SERVICE BULLETIN REVISION TRANSMITTAL SHEET

MODEL BD-100-1A10 (CH-350)

Service Bulletin No.	<u>350-23-004</u>		
Date of Basic Issue	<u>Apr 11/2014</u>		
Revision No.	<u>01</u>	Dated	<u>Jun 18/2014</u>
Revision No.	<u>02</u>	Dated	<u>Nov 26/2015</u>
Revision No.	<u>03</u>	Dated	<u>Apr 19/2016</u>
Revision No.	<u>04</u>	Dated	<u>Oct 07/2016</u>
Revision No.	<u>05</u>	Dated	<u>Nov 08/2016</u>
Revision No.	<u>06</u>	Dated	<u>Nov 17/2022</u>
Revision No.	<u>07</u>	Dated	<u>Jan 30/2023</u>
Revision No.	<u>08</u>	Dated	<u>Aug 09/2023</u>

MODIFICATION – DATALINK AND SELCAL SYSTEM – INSTALLATION OF DATALINK WITH SELECTIVE CALLING (SELCAL) OPTION (C23-406)

Datalink External Compensation-Unit – Installation
Figure 1

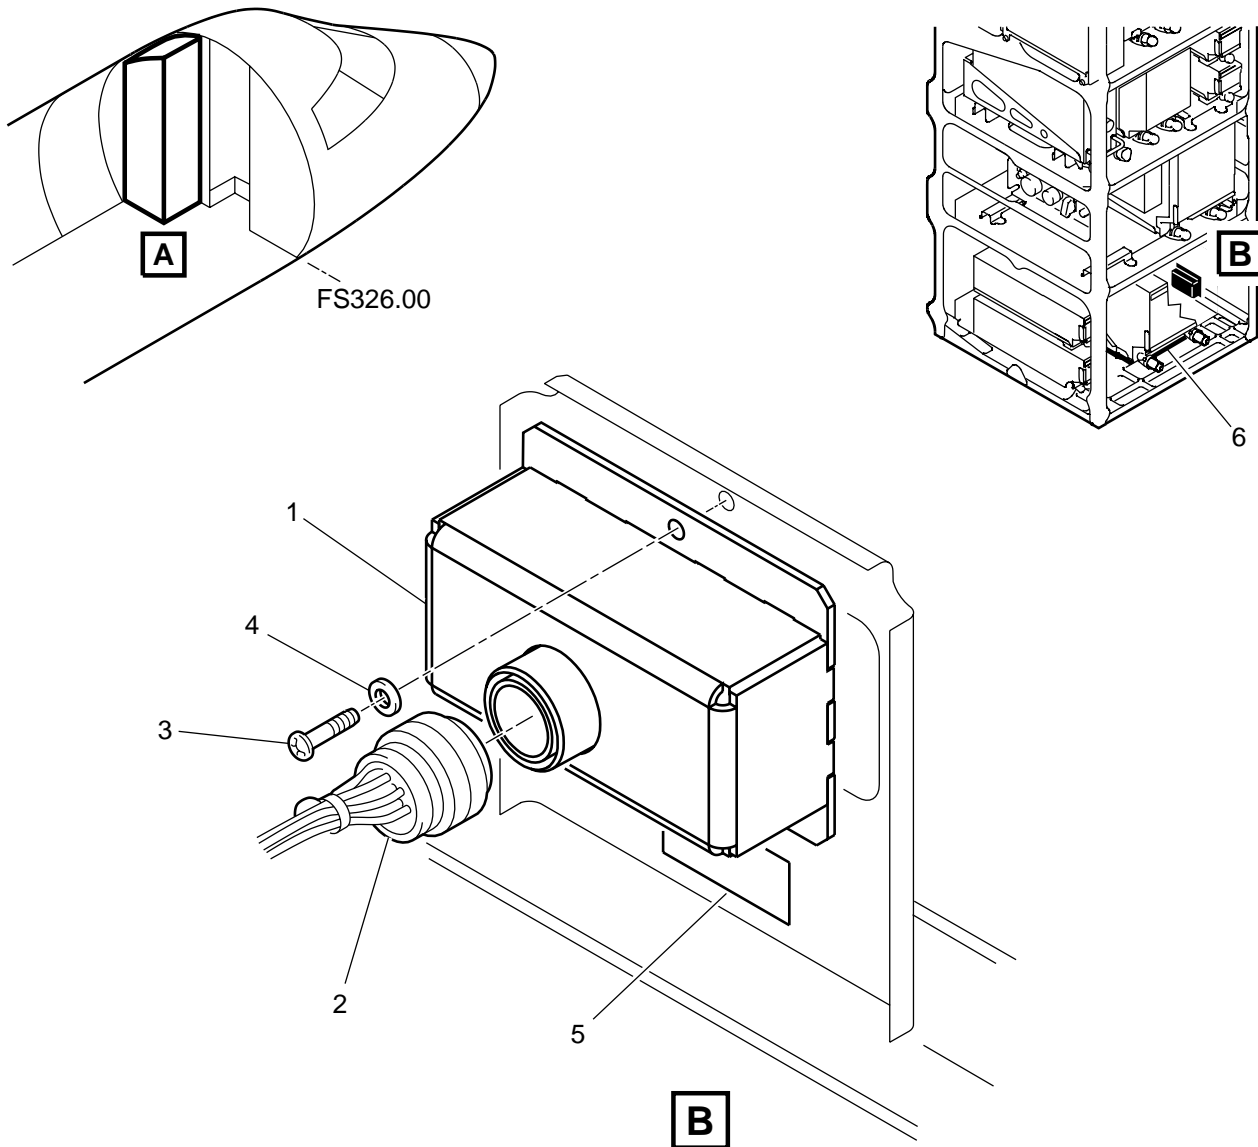
- (4) Install the datalink ECU, Part No. 822-1200-996. Refer to Figure 1 and to the steps that follow.

(a) Torque the screws from 10 to 13 lbf in (1.13 to 1.46 Nm). Refer to SPM-MM 20-21-00-910-801.

(b) Do the electrical bonding test of the datalink ECU. Refer to SPM-MM 51-80-00-760-801.

NOTE: The maximum allowable resistance is 5 milliohms between the mounting surface of the datalink ECU and the aircraft primary structure.

(c) Install the electrical identification decal, Part No. K1005330035-007/01. Refer to SPM-MM 20-80-01-400-801.

RIU – Indexing Key Modification
Figure 2

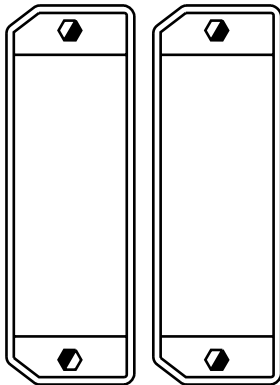
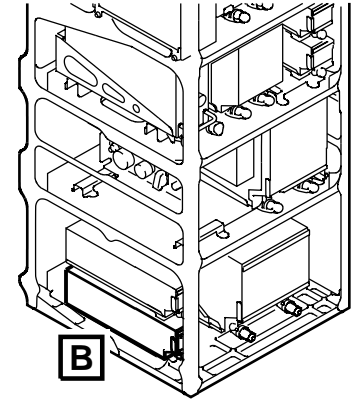
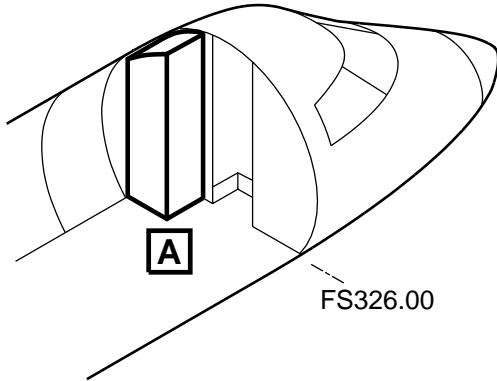
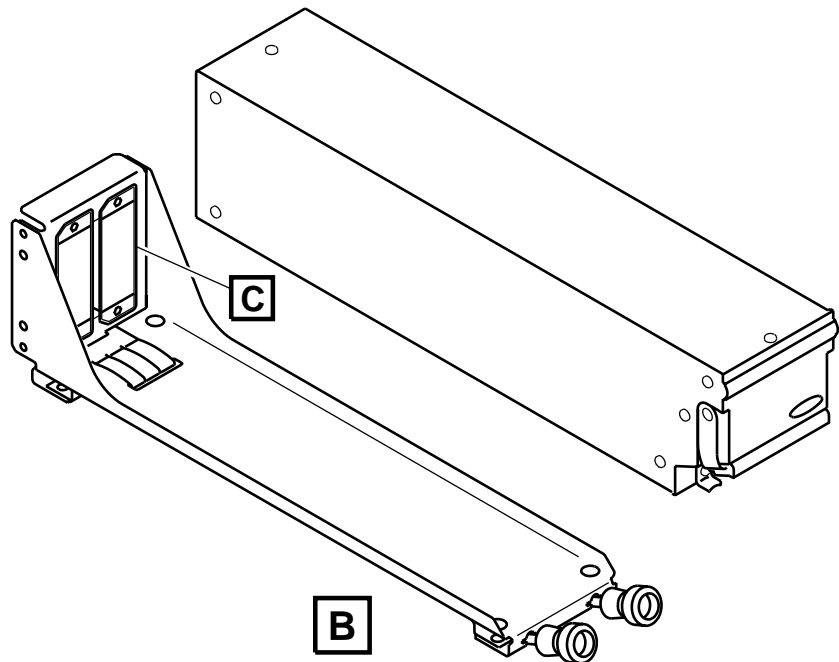
- (1) Set the tray polarizing keys and replace the Radio Interface Unit (RIU) No. 1 (A17). Refer to Figure 2 and to the table that follows:

UNIT NAME	REMOVAL AMM 23-51-21-000-801	INSTALLATION AMM 23-51-21-400-801
RIU No. 1 (A17)	Old Part No. 822-1590-152	New Part No. 822-1469-652 or New Part No. 822-1469-653

NOTES: 1. For aircraft S/N: 20501 to 20936 or PRE SB350-22-002 (S/N: 20875 to 20936) and POST 350-23-002 and POST 350-23-003 install RIU P/N: 822-1469-652.

2. For aircraft S/N: 20937 to 22999 or POST SB350-22-002 (S/N: 20875 to 20936) and POST 350-23-003 install RIU P/N: 822-1469-653.
